PA&A 2022-12 Trailer Hitch Installation on MY22 Can-Am Spyder - Rear Wheel Axle Replacement Needed

Product: **PA&A**
 Bulletin type: **Quality**
 Bulletin no: **2022-12** (rbg2022-012 en LG)
 Revision no:
 Revision date:
 Campaign no.:
 Publication date: **June 9, 2022**
 Subject: **Trailer Hitch Installation on MY22 Can-Am Spyder - Rear Wheel Axle Replacement Needed**

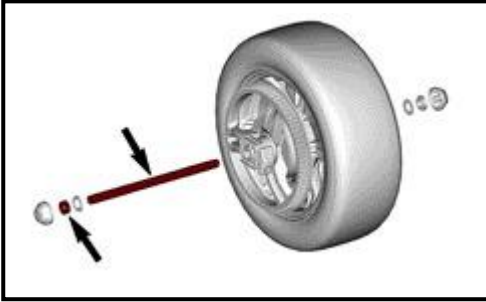
When trying to install a trailer hitch kit, the internal diameter of the stock rear axle is too small to install the trailer hitch axle.

Replace the rear wheel axle and nut.

Description	part number	QTY
Rear wheel axle	705501691	1
Axle nut	250100170	1
